Project: New Ultimo Pyrmont Public School - State Significant Development DA

Report: Access Assessment Report

Reference No: 106876-Access-r5

Date: 24th October 2017

B 1

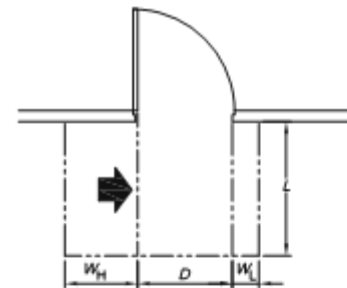
- 11 Accessible car spaces will achieve compliant headroom clearances in accordance with Clause 2.4 of AS2890.6-2009.
- 12 Demarcation will be provided in the accessible car space and adjacent shared zone in accordance with Clause 3.1 and 3.2 of AS2890.6. Refer to Annexure B1 for a diagrammatic explanation.

- 13 Bollards will be provided in the shared disabled car space area in accordance with Clause 2.2.1(e) of AS2890.6-2009. Refer to Annexure B1 for a diagrammatic explanation.

FIGURE 31 (in part) CIRCULATION SPACES AT DOORWAYS WITH SWINGING DOORS

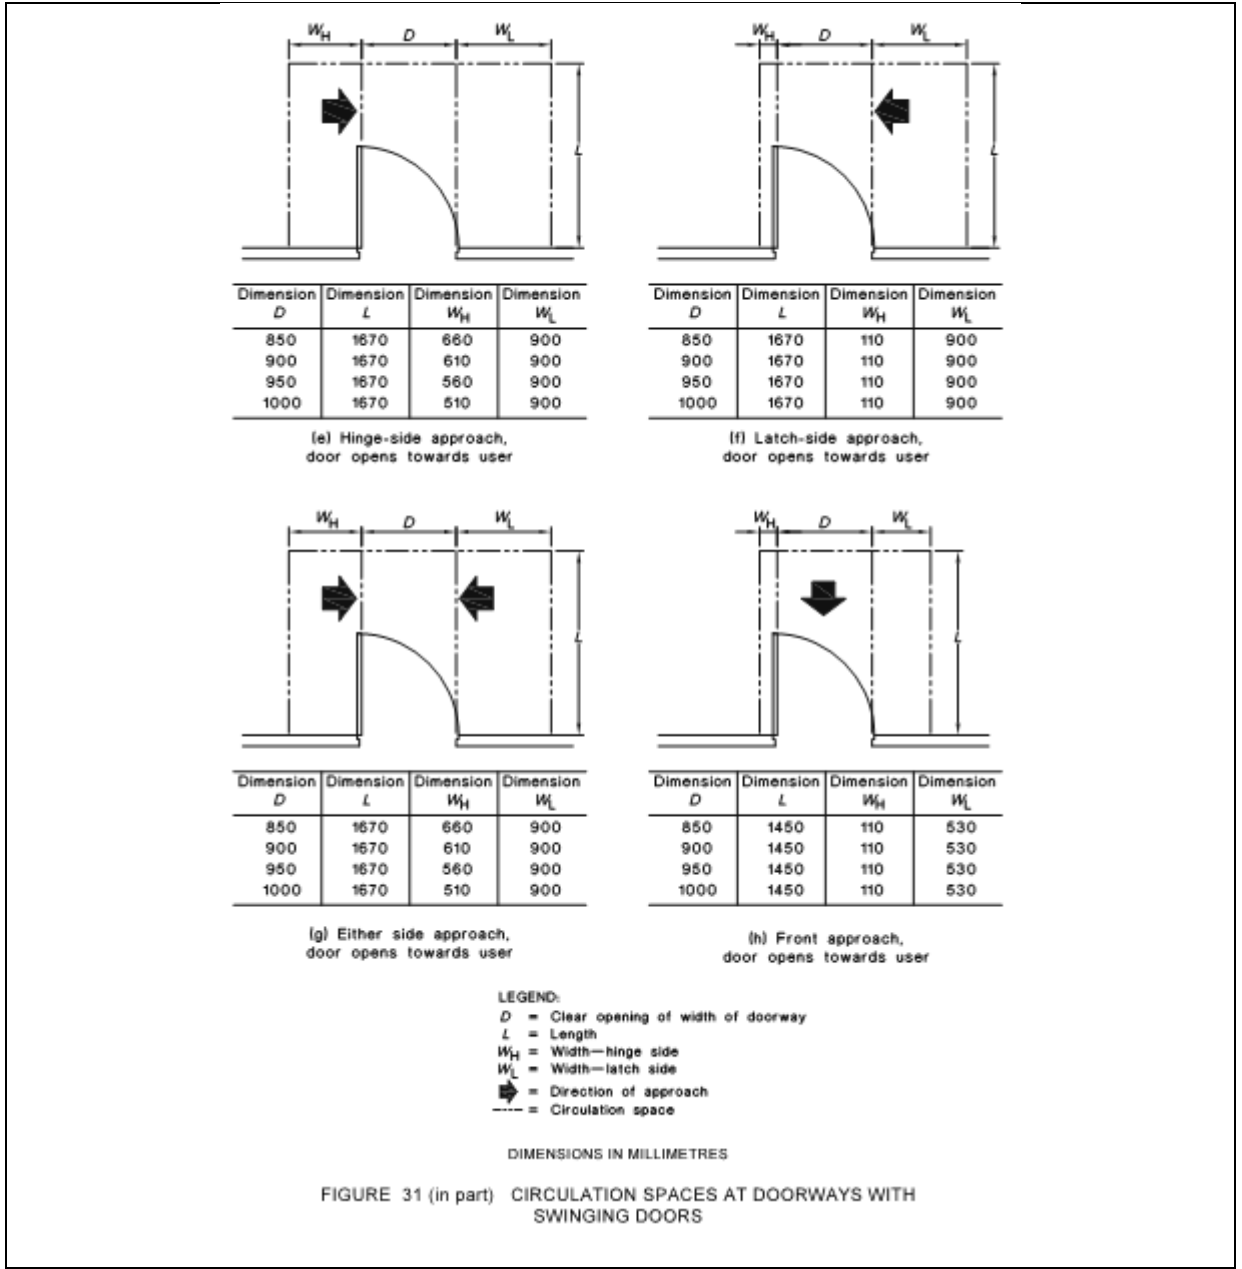
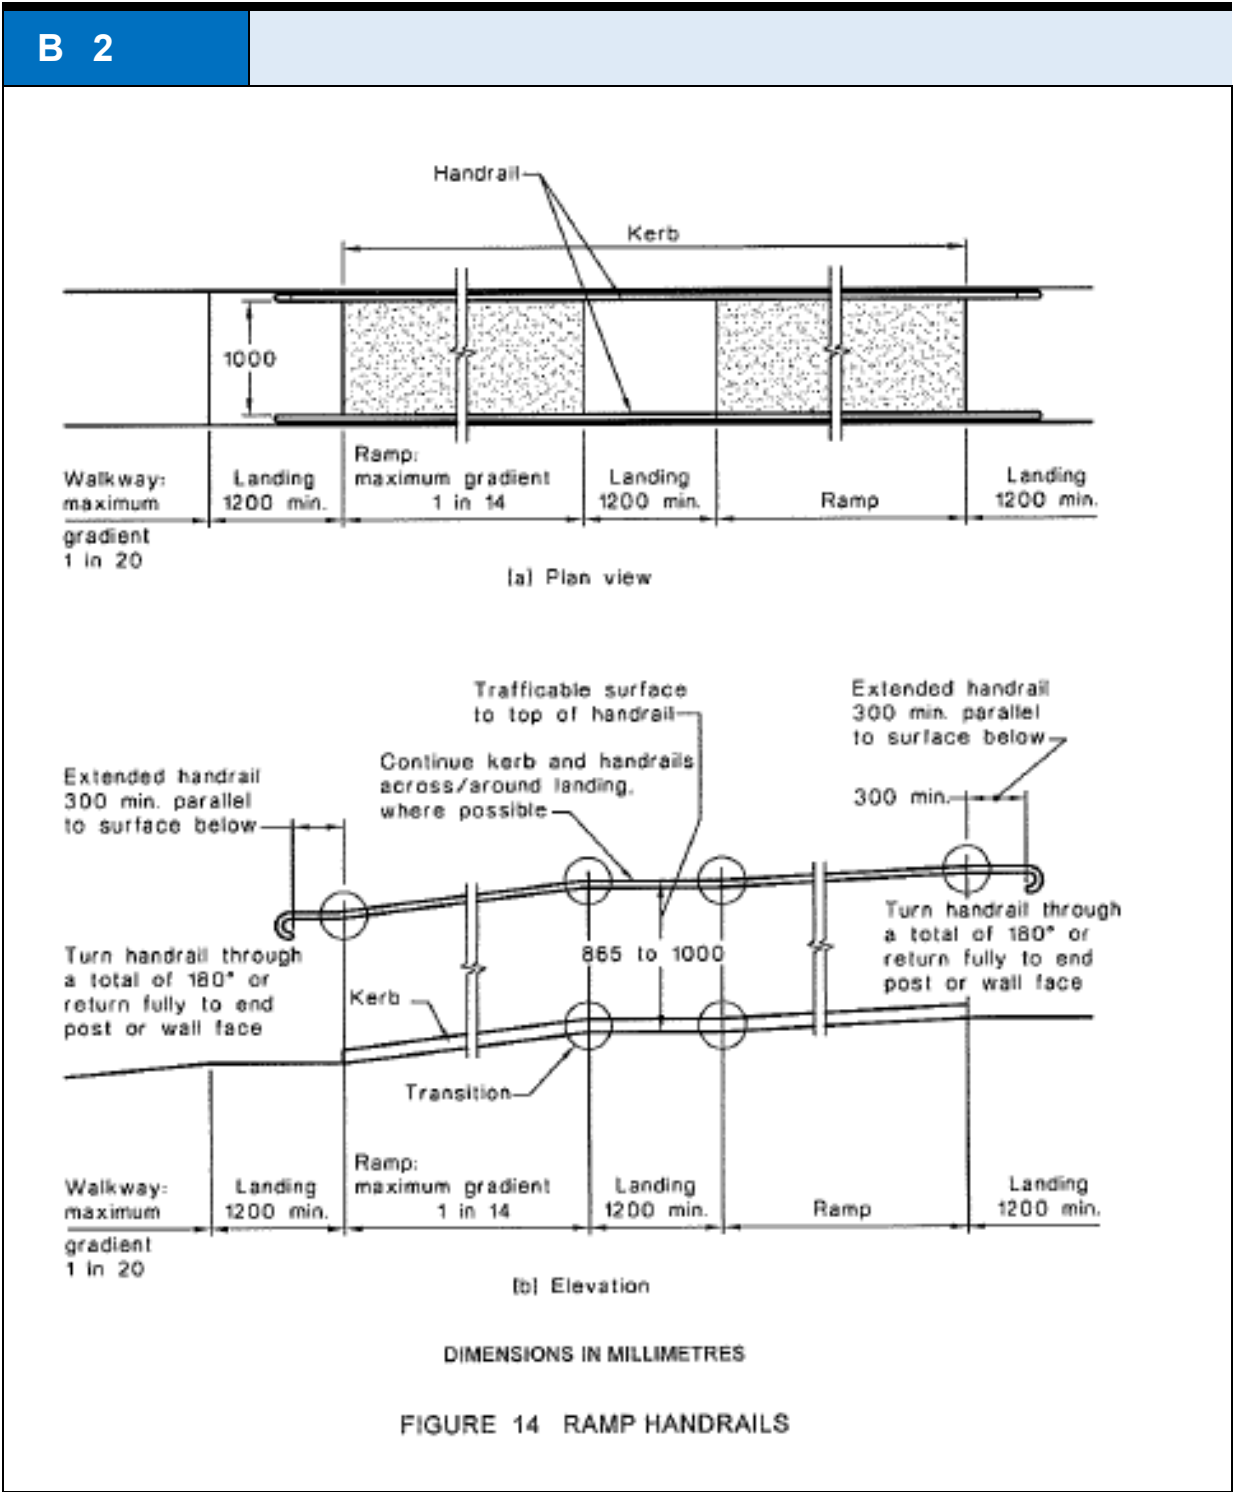
All doors must have circulation space compliant with Figure 31 of AS 1428.1-2009. The doors in the corridors of the admin areas on Level 3 should be positioned accordingly.

FIGURE 53(B) SANITARY COMPARTMENT FOR PEOPLE WITH AMBULANT DISABILITIES—DOORWAY OPTIONS

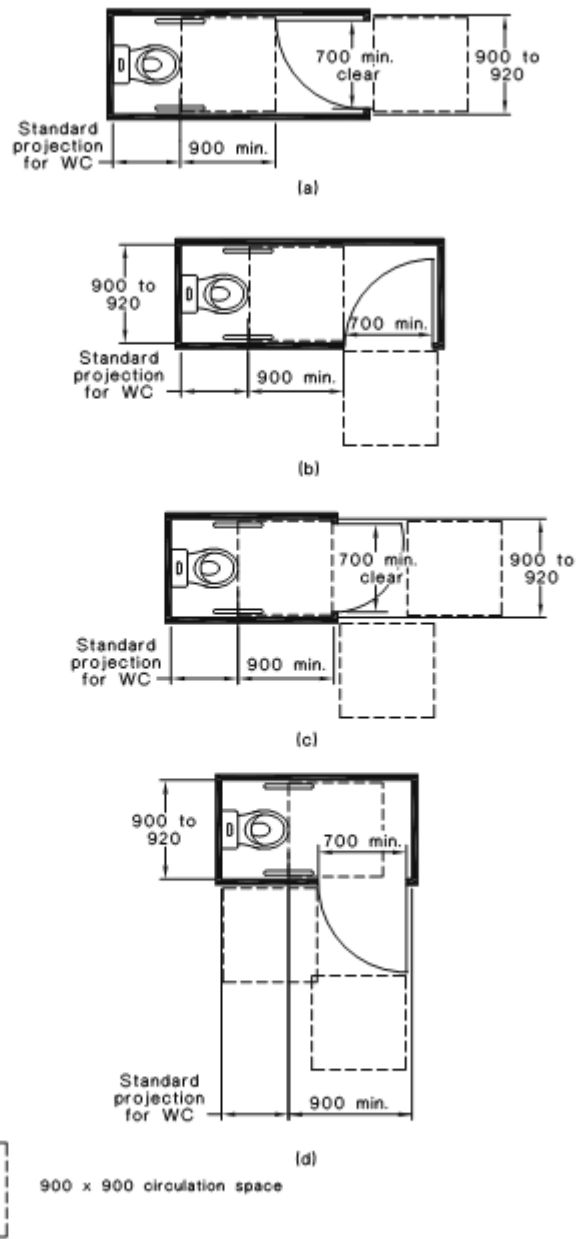
The ambulant toilets must have pan and door circulation space compliant with Figure 53(b) of AS 1428.1-2009. It is recommended that the doors to the compartments be swung outwards to comply, as in the current design the basin encroaches on the 900x900mm space required in front of the door within the compartment.
